**Lee Nuclear Station Units 1 and 2  
Description, Scope of Changes, and FSAR Impacts due to Plant Relocation and  
Additional Design Enhancements**

**Description and Rationale for Lee Nuclear Station Units 1 and 2 Relocation and  
Additional Design Enhancements**

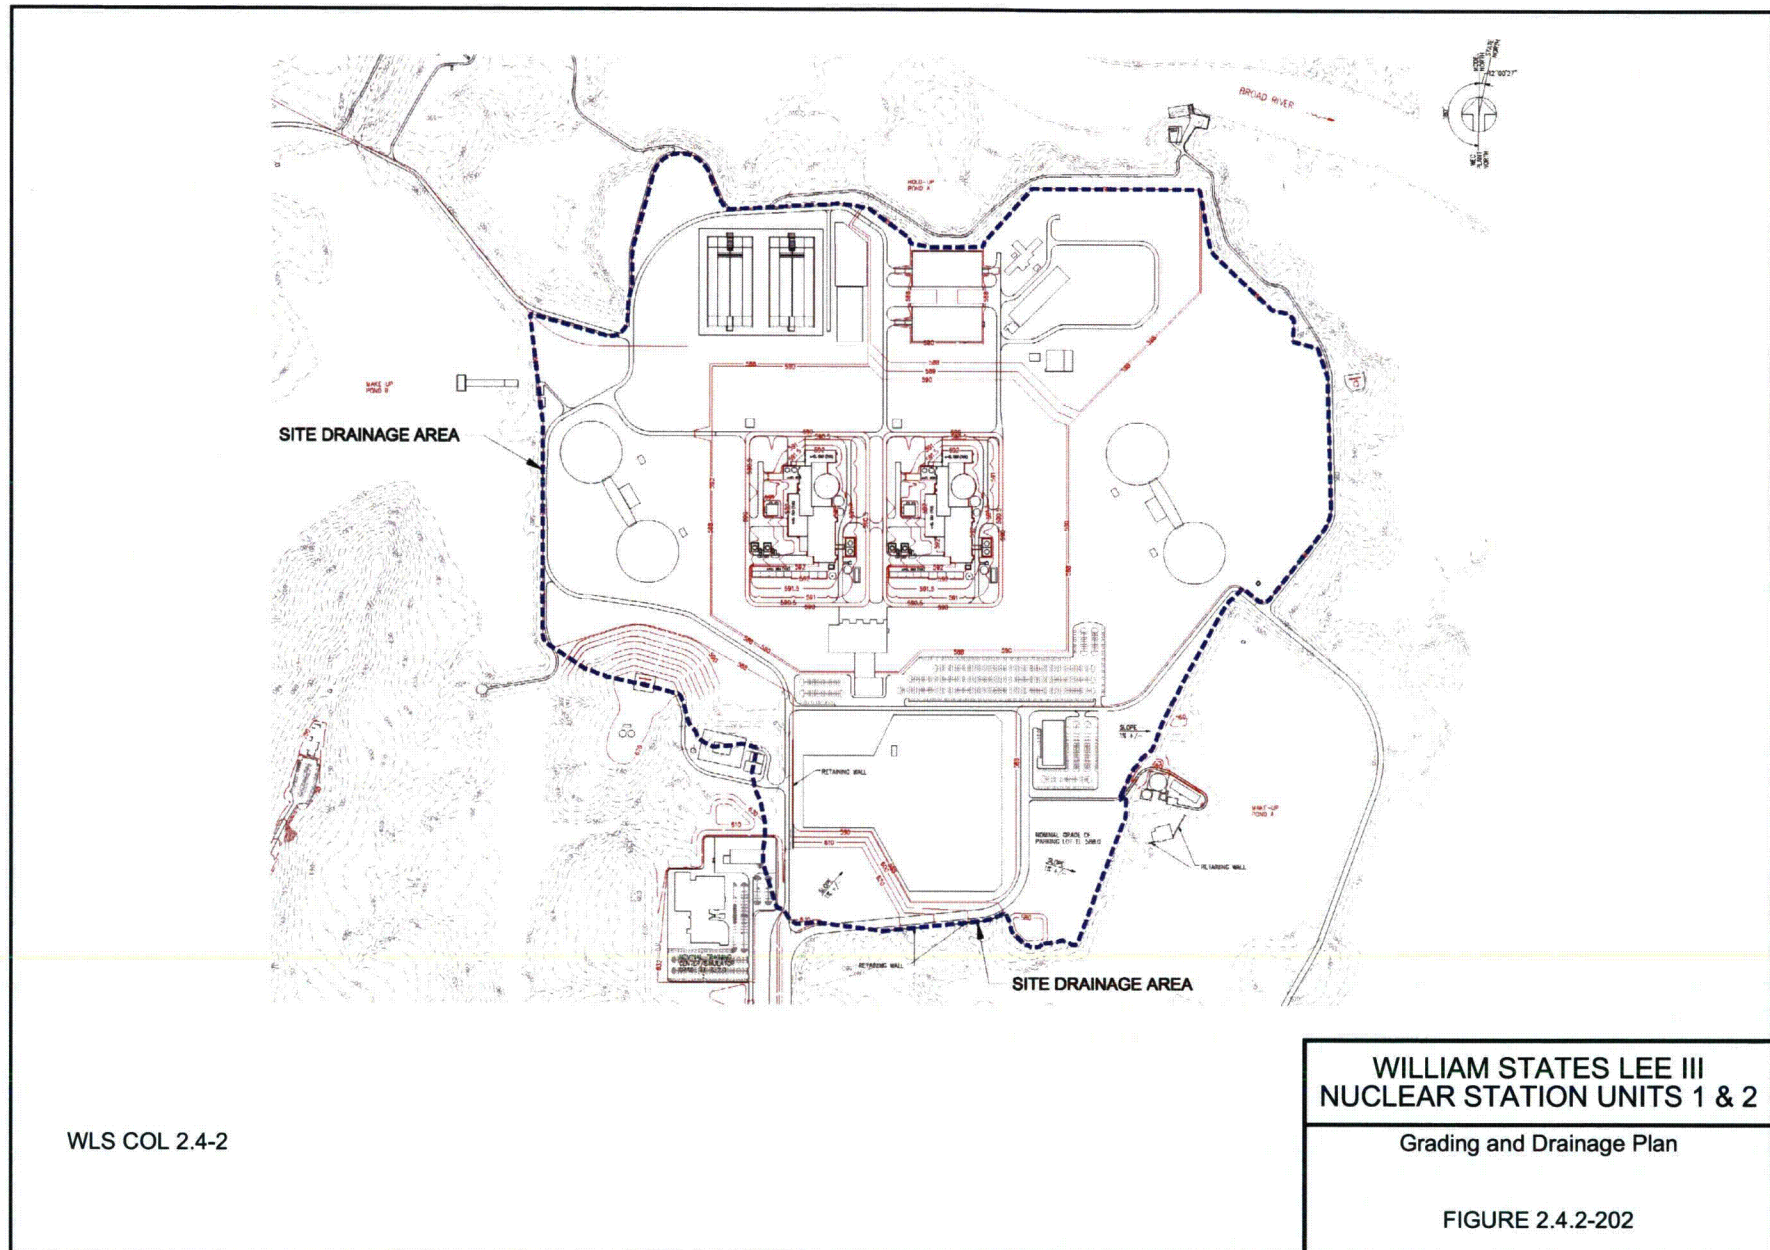
43. COLA Part 2, FSAR Chapter 2, Figure 2.4.1-214 is revised as follows:

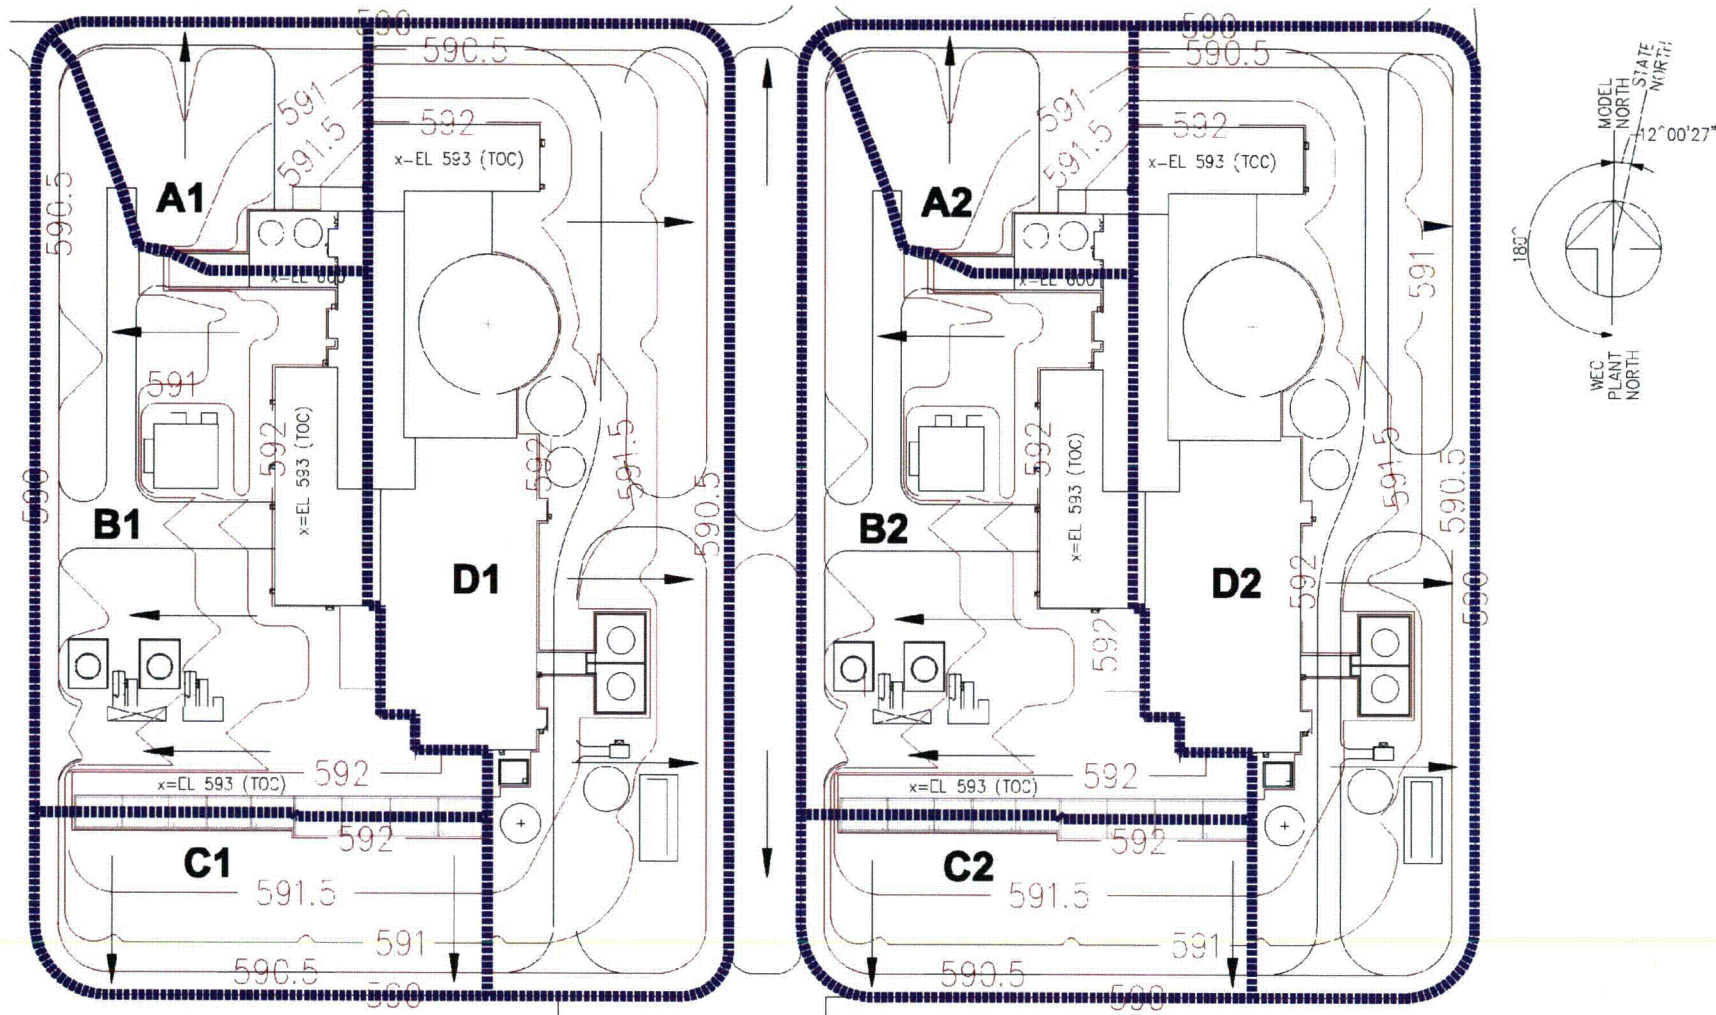
~~Portions of the site are relatively flat; however~~ The site is generally defined by wide flat areas. ~~However,~~ the site is graded such that runoff will drain away from safety-related structures either to Make-Up Pond B, Make-Up Pond A, or directly to the Broad River ~~through five grass covered drainage channels. These channels, illustrated in Figure 2.4.2-202, are assumed to be the only flow paths for runoff from the site and establish the downstream boundary conditions for site runoff for modeling purposes.~~ Runoff from a specific power block area flows through four graded channels per unit as described in the discussion below and then ~~through the five site discharge channels~~ flows across the site to the receiving water body. Computed water surface elevations in the vicinity of safety-related structures are below plant elevation ~~590-593~~ 593 ft. The site grading and drainage plan is shown in Figure 2.4.2-202.

44. COLA Part 2, FSAR Chapter 2, Figure 2.4.2-202 is revised as follows:

FIGURE 2.4.3-201

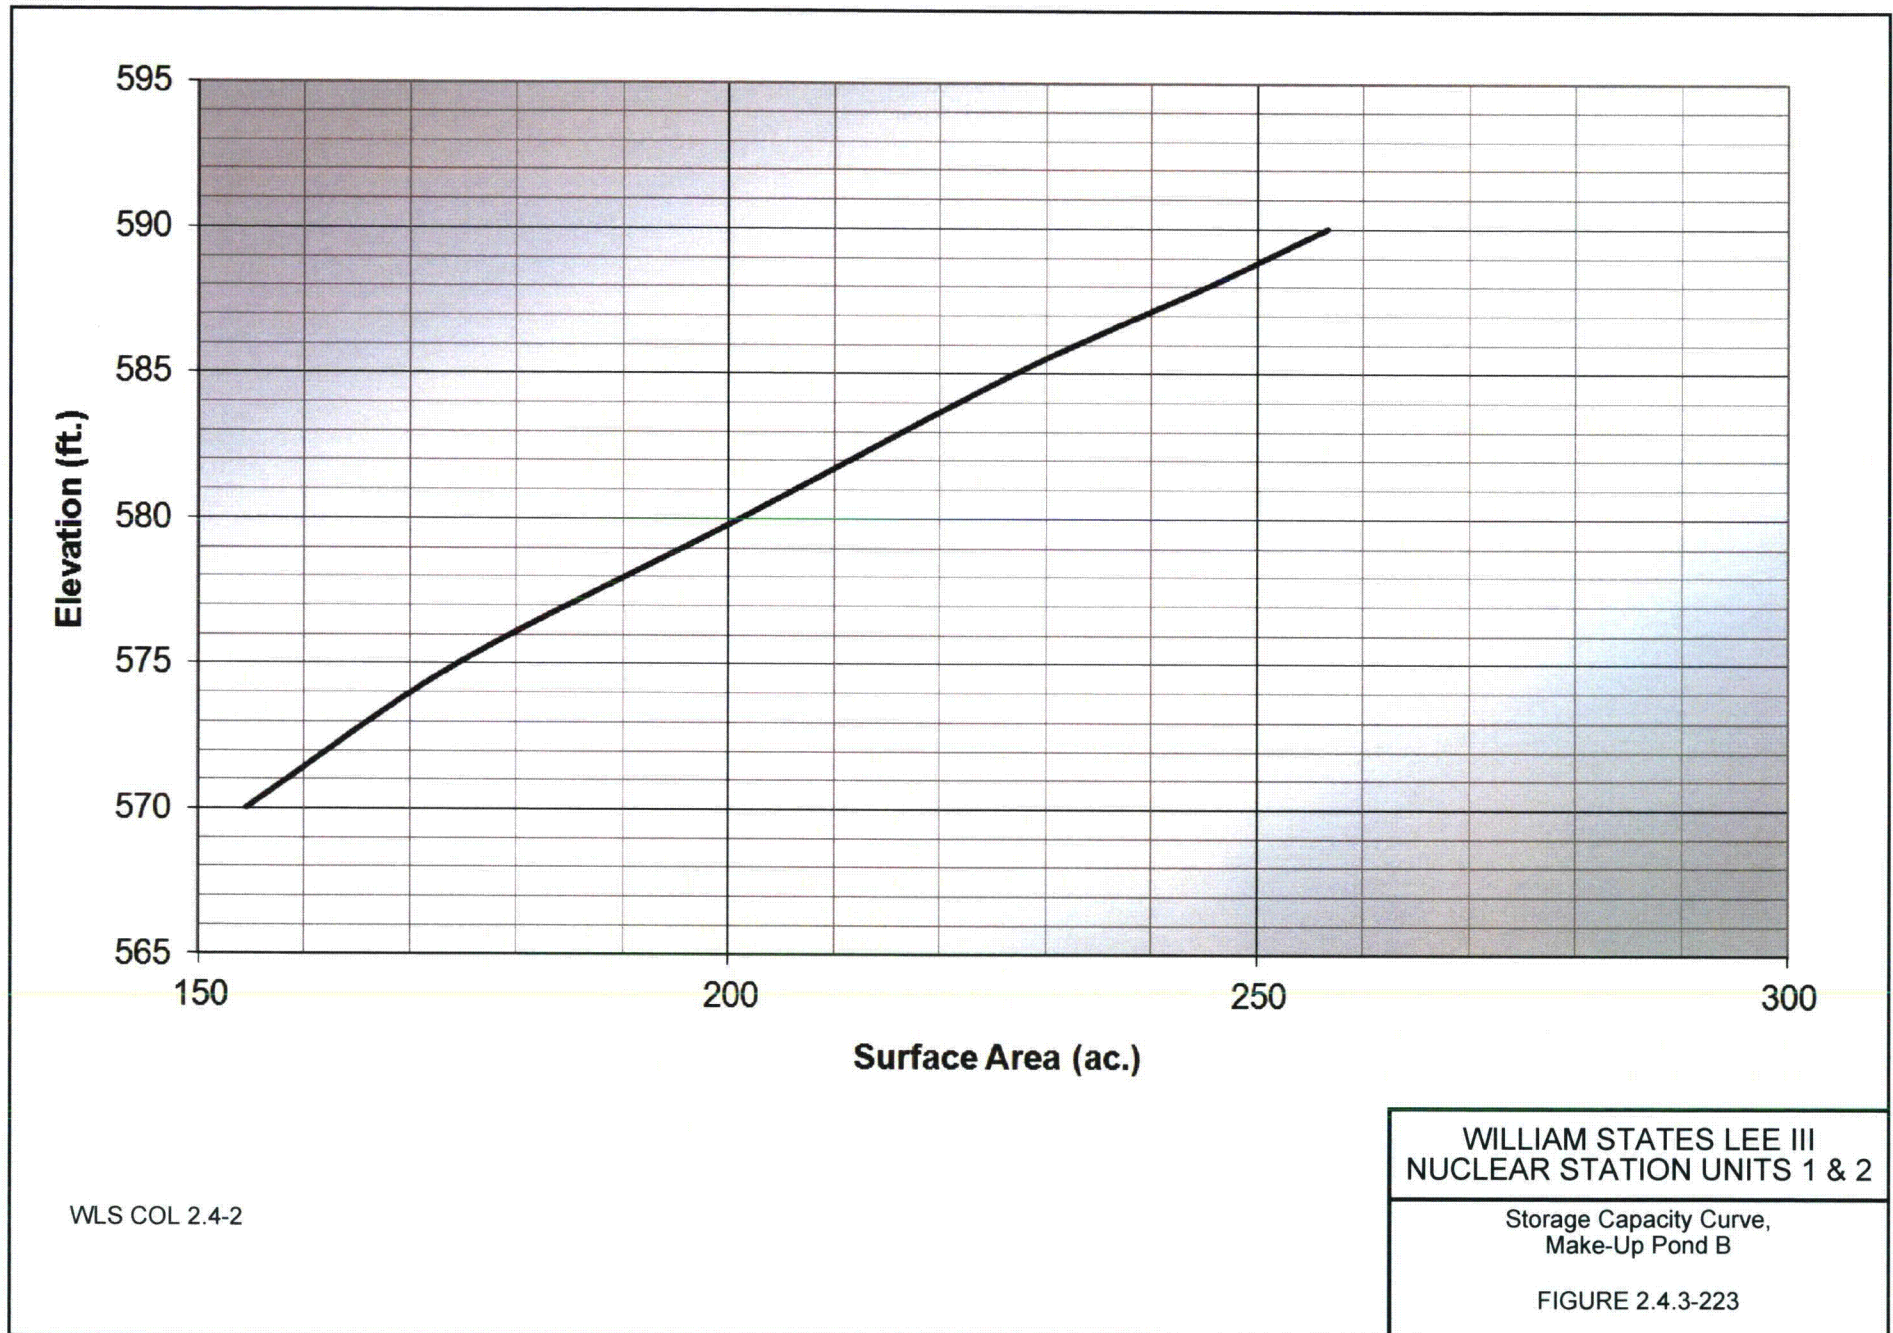
The PMF for McKowns Creek and Make-Up Pond B is determined from the PMP for the 2.2332.190-sq. mi. drainage basin of Make-Up Pond B and the 0.2830.294-sq. mi drainage basin of the Upper Arm. The Make-Up Pond B drainage basin, including the Upper Arm, is shown in Figure 2.4.3-201.

46. COLA Part 2, FSAR Chapter 2, Figure 2.4.3-201 is revised as follows:

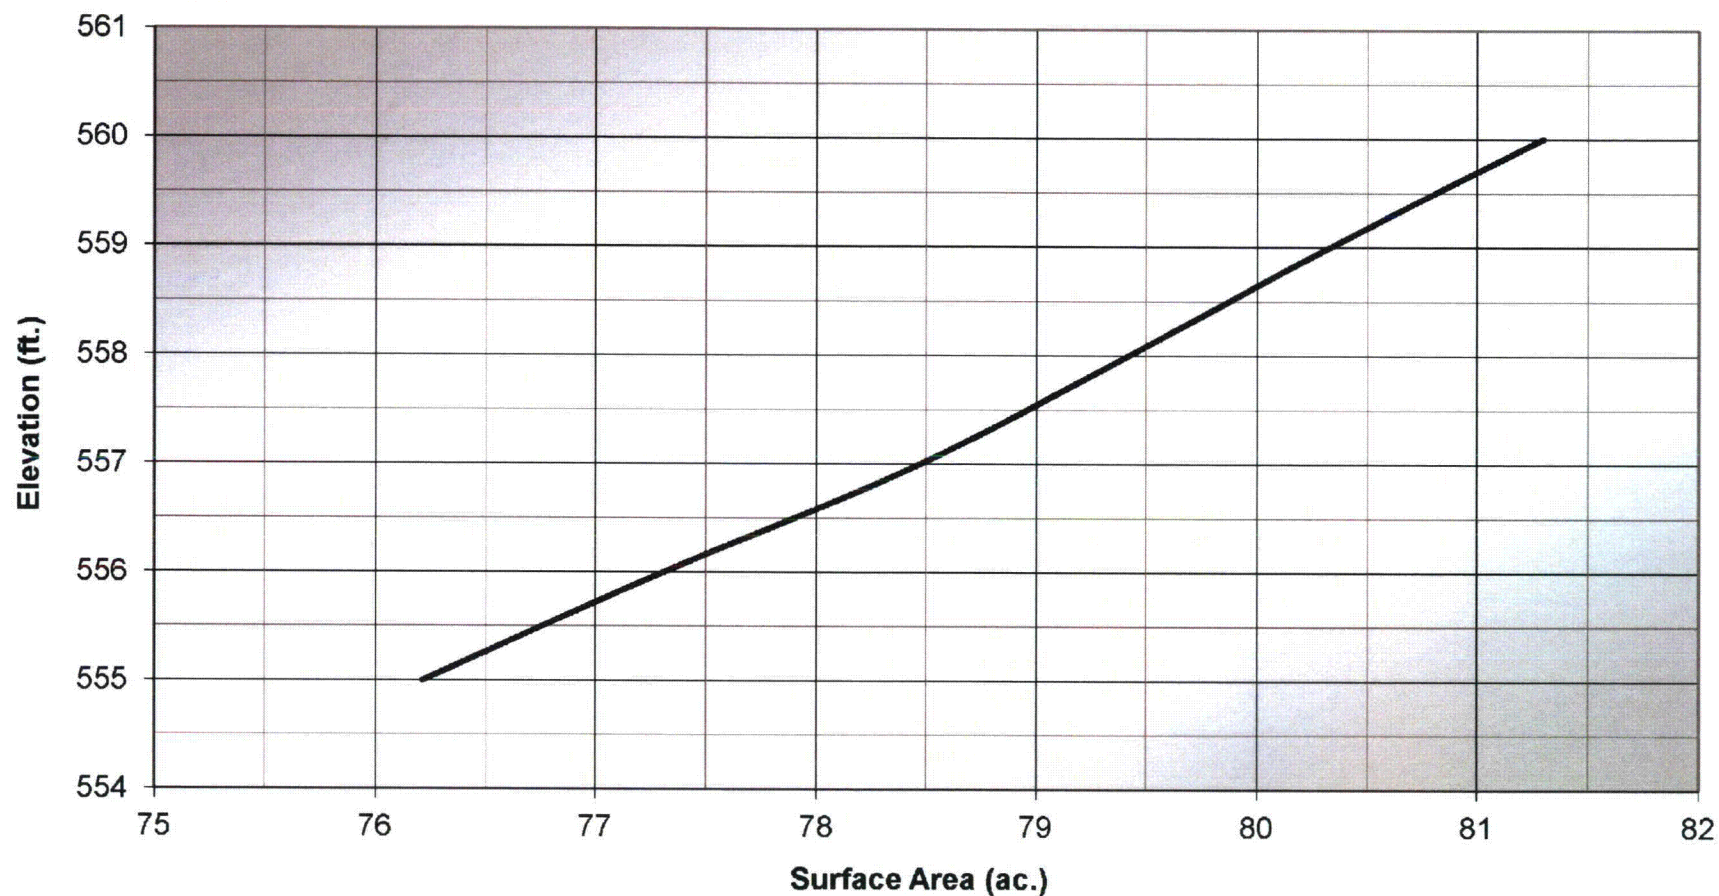
47. COLA Part 2, FSAR Chapter 2, Figure 2.4.3-223 is revised as follows:

FIGURE 2.4.3-225

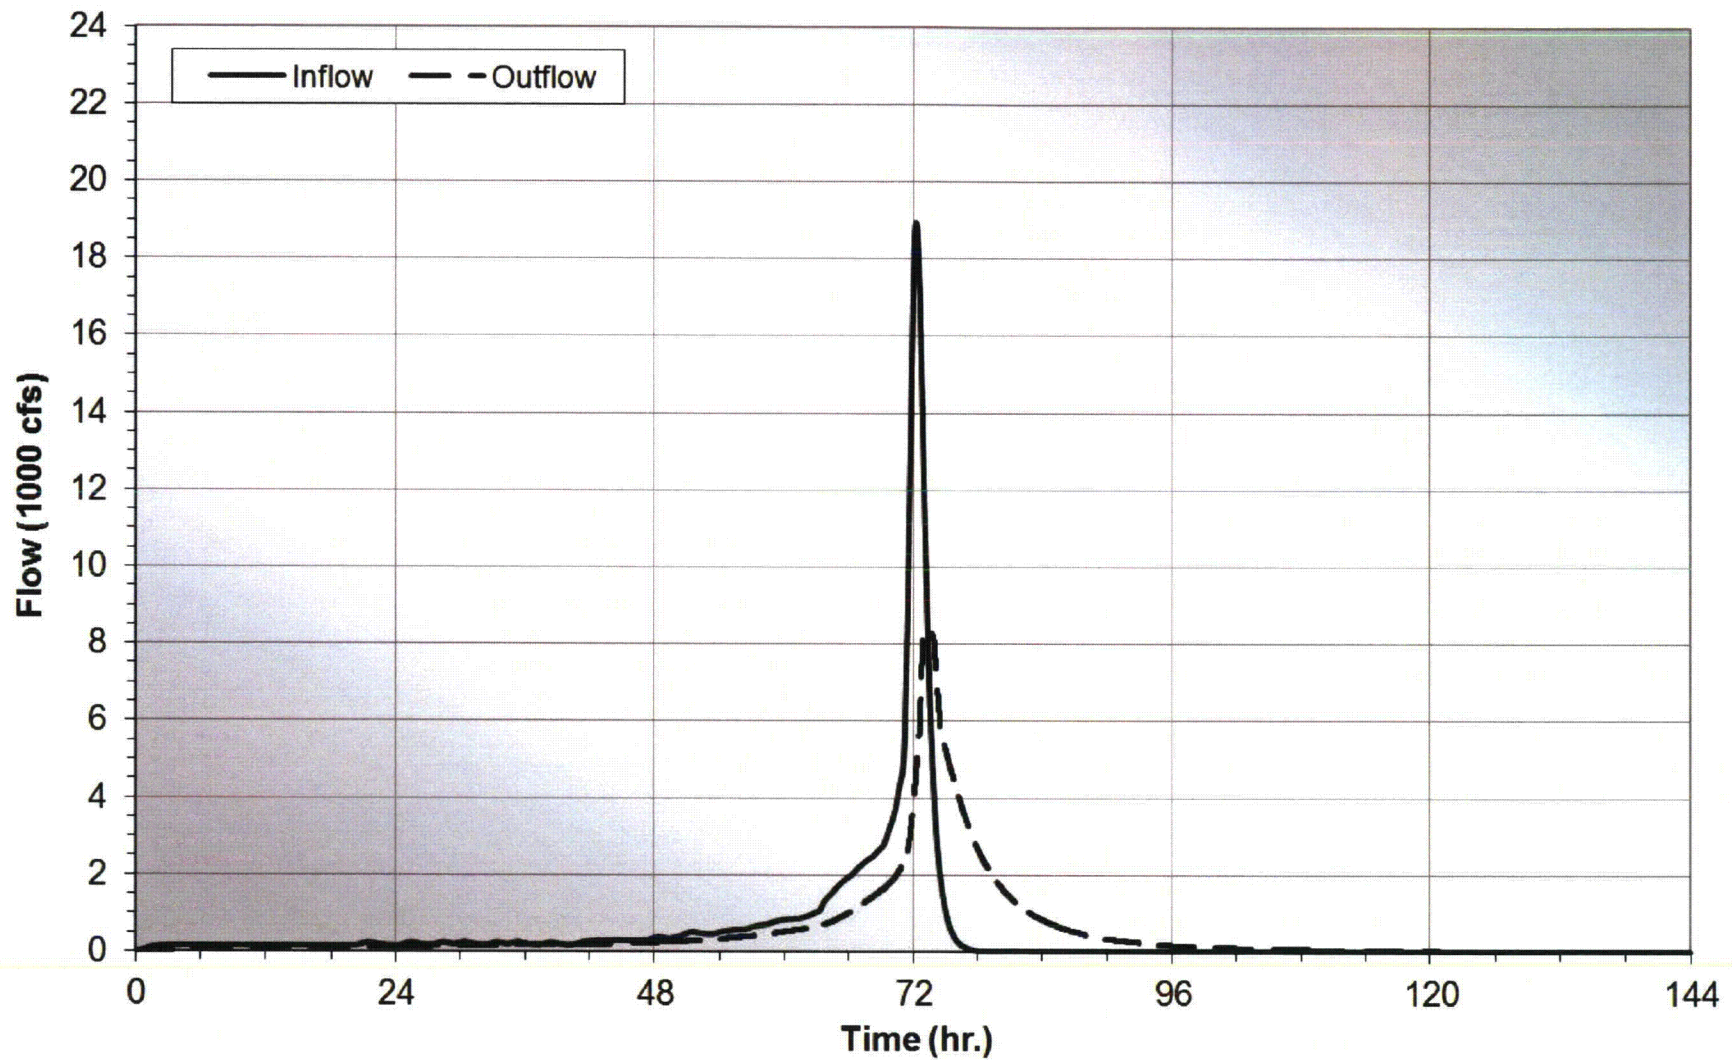
48. COLA Part 2, FSAR Chapter 2, Figure 2.4.3-225 is revised as follows:
